## Memorandum

**SUBJECT: Shawville Addition**

Resubdivision of Lots 1, 2, 3 & Reservoir Tract, Evergreen Park  
Subdivision and Lot 1, Block 8, Evergreen Park No. 2

**Case Number:** 23.03 FSP

PLAT OF  
**"SHAWVILLE ADDITION"**  
 TO THE CITY OF MILLS, WYOMING  
 A SUBDIVISION LOCATED IN AND BEING A PORTION OF THE  
 SW1/4NW1/4, SECTION 12, TOWNSHIP 33 NORTH, RANGE 80 WEST  
 OF THE SIXTH PRINCIPAL MERIDIAN, NATRONA COUNTY, WYOMING.

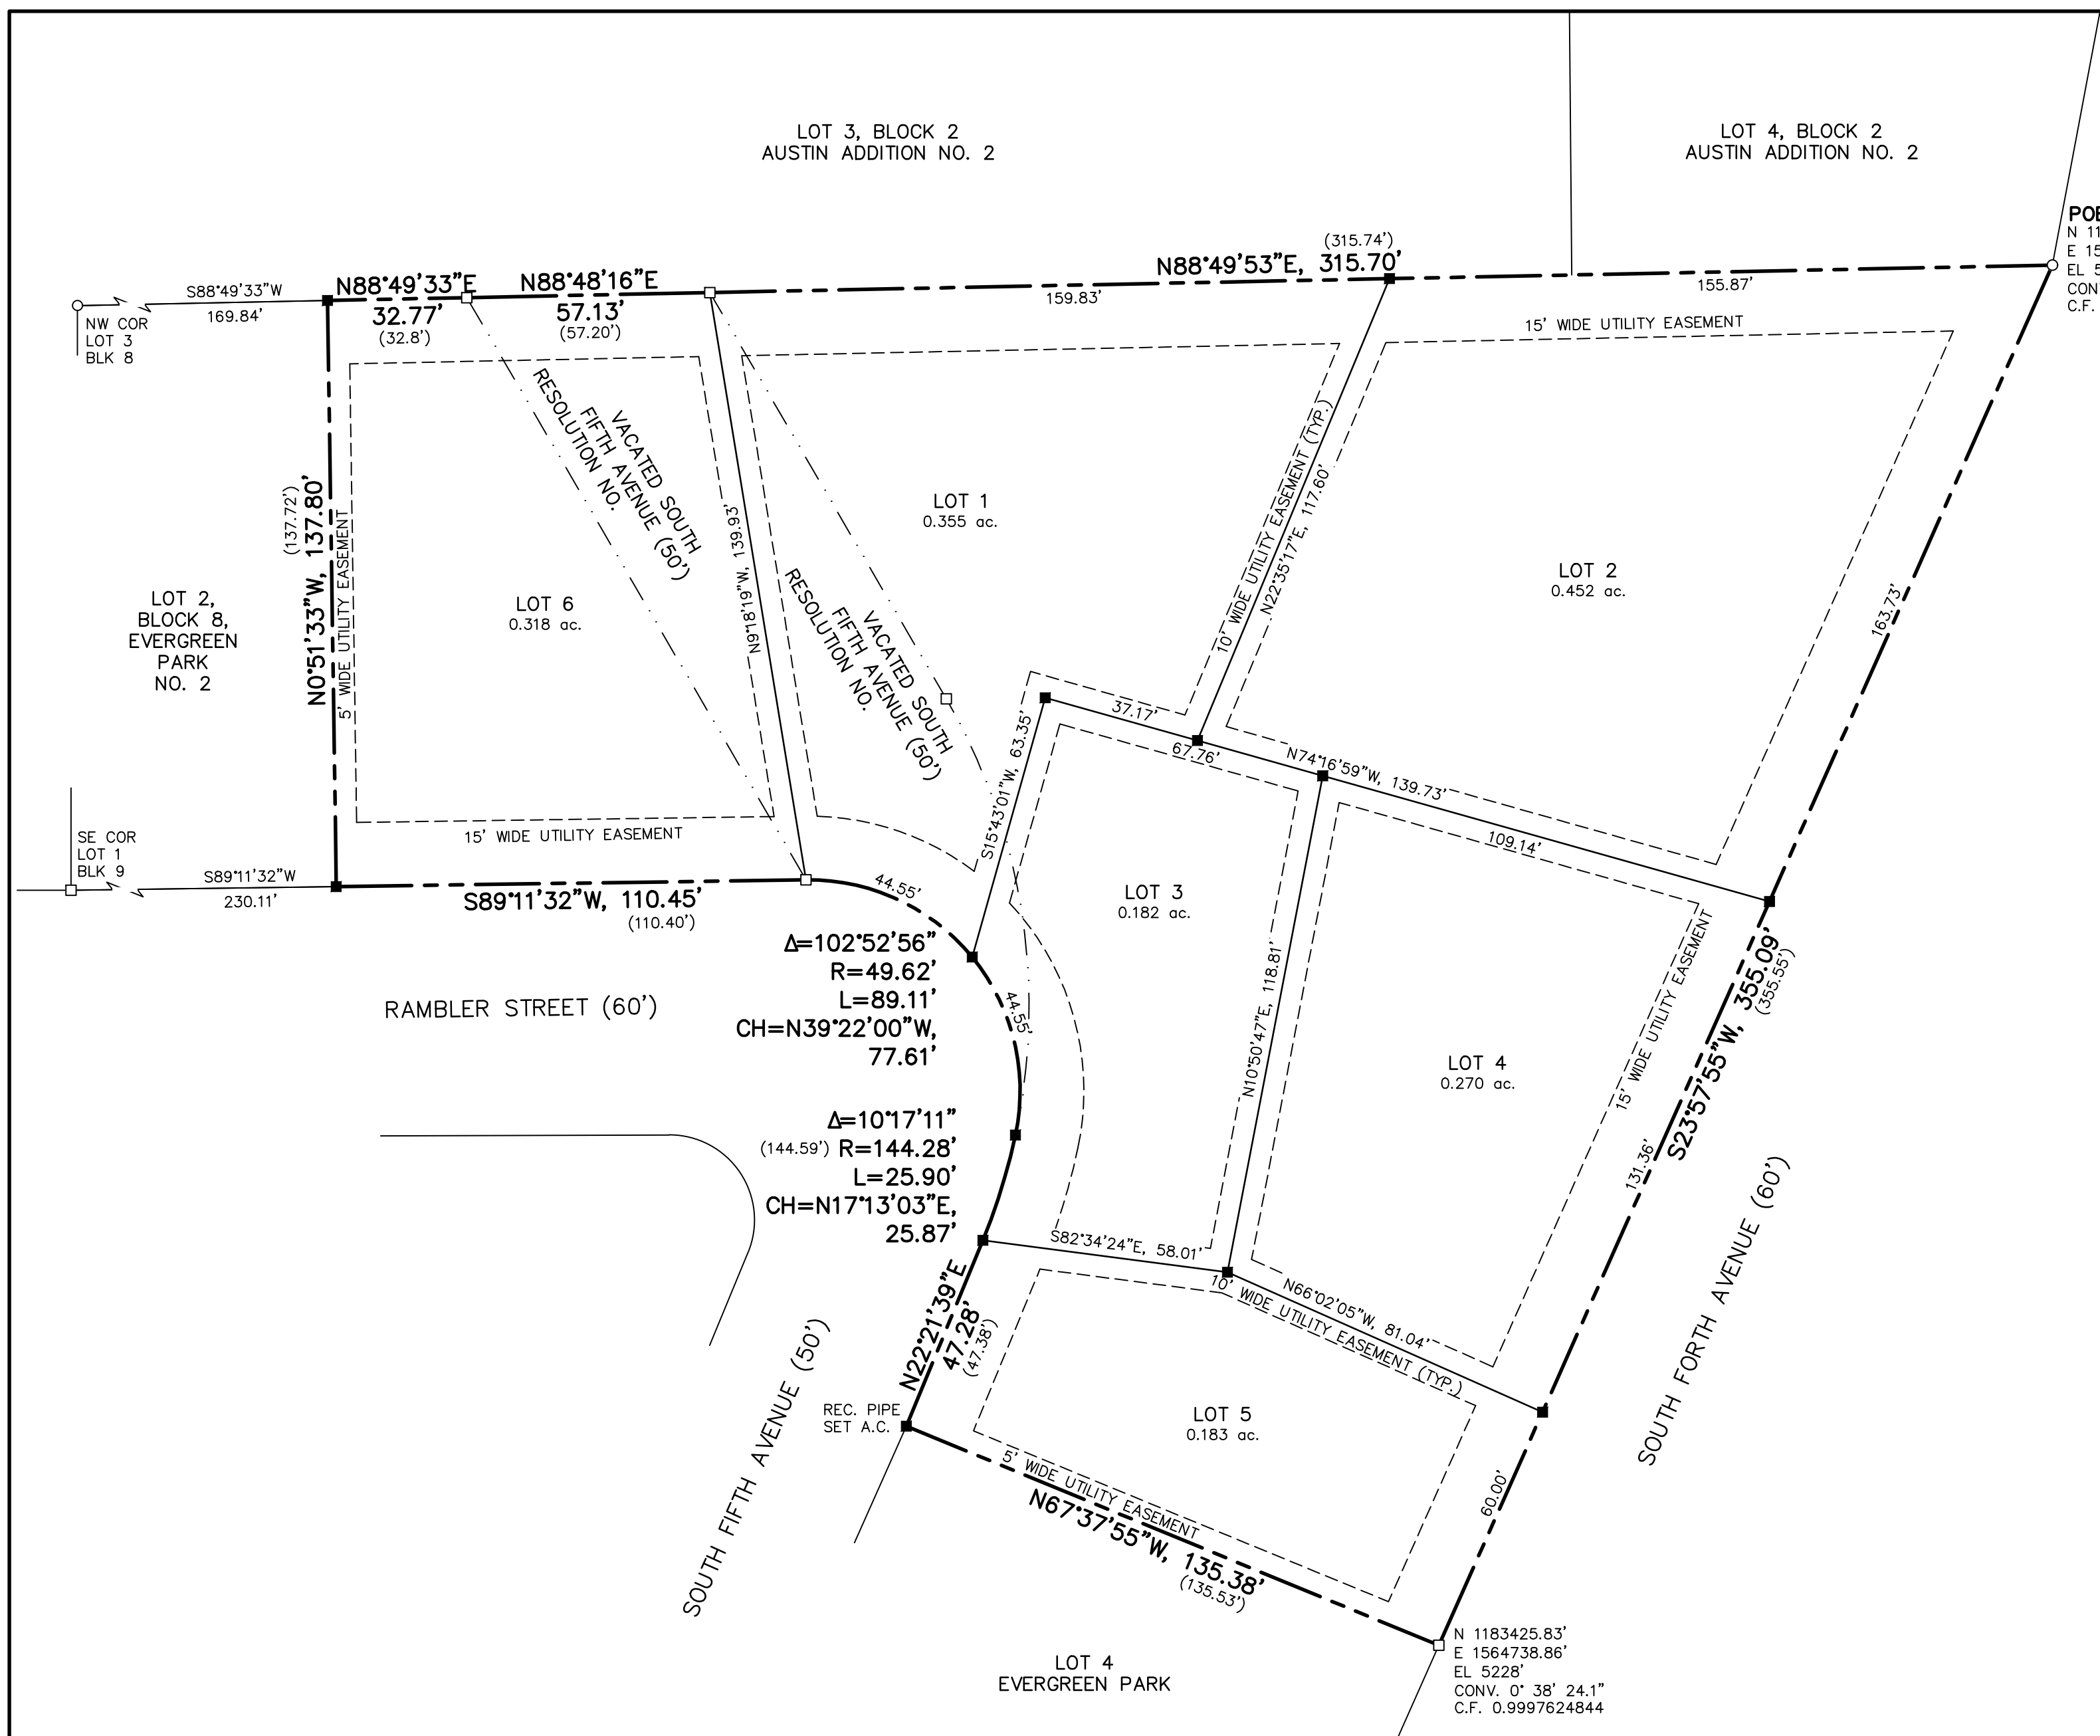
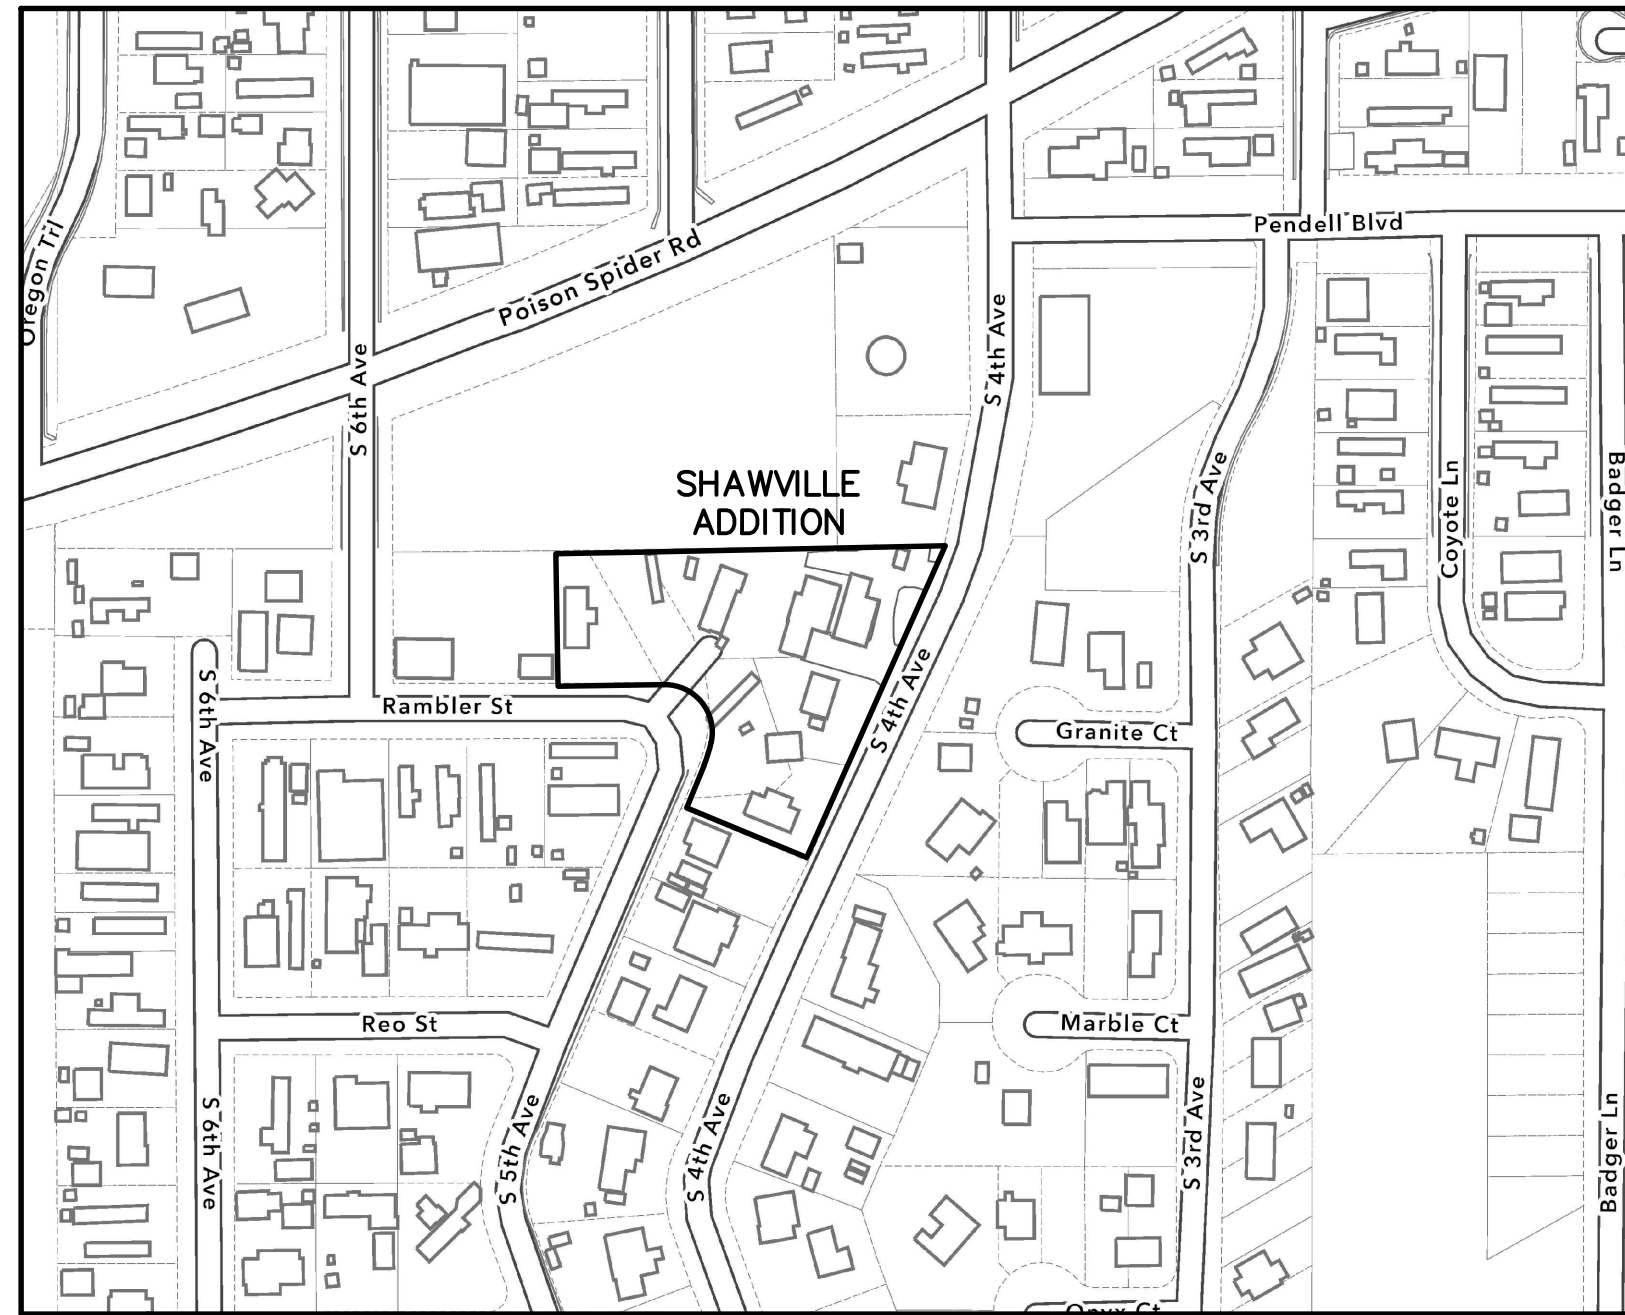
1. Verify the record owner name for the neighboring property included in the resubdivision (Lot 1, Block 8, Evergreen Park II)
2. Cosmetic Changes to the Plat
  - a. Remove the word "Attest" the City Engineer's signature
  - b. Add a legend to the plat face
3. Submit organizational documents for Shaw Investments, LLC showing who is authorized to sign on behalf of the organization.

4. Add a legend for the lines – easements property boundaries, etc.
-

1. Modify the plat to include the vacation of that portion of S. 5<sup>th</sup> Avenue and
  - a. Revise the plat title & description to include the vacation of that portion of S. 5<sup>th</sup> Avenue and Lot 1, Blk 8, Evergreen Park No. 2

- b. Modify Lot 1 and Lot 2, Blk 8 to include that vacated portion of S. 5<sup>th</sup> Avenue
  - c. Ensure all standards are met including:
    - i. Minimum lot width of 40’

- ii. All lots have access to publicly dedicated right of way
  - d. Submit a revised plat for review
2. Verify the location of all utilities and the need for any applicable utility easements

- a. Verify the needed 15’ utility easements
  - b. Ensure only needed easements are provided for the vacated portion of right of way
3. Cosmetic Changes to the Plat

- a. The owner name across the plat needs to be “Shaw Investments, LLC” per the warranty deed.
  - b. Change the name of the neighboring landowner joining the subdivision to Kimberly Perez not Sylvester Graham

- c. In the notary block, add “Managing Member” after Albon Shaw’s name
  - d. Remove the word “Attest” from the Mayor & Engineer’s signatures
4. Submit organizational documents for Shaw Investments, LLC showing who is

5. Add a legend for the lines – easements property boundaries, etc.

Megan stated that the applicants had turned in a revised plat the day before, showing the unbuilt portion of S. 5<sup>th</sup> Avenue being vacated. They also added the neighboring property owner so that the vacated portion of right of way is equally distributed between the lots and have reconfigured the lots so all have the required amount of street frontage. The City will also now sign the plat as owner since they represent the public in the vacation of the right of way.
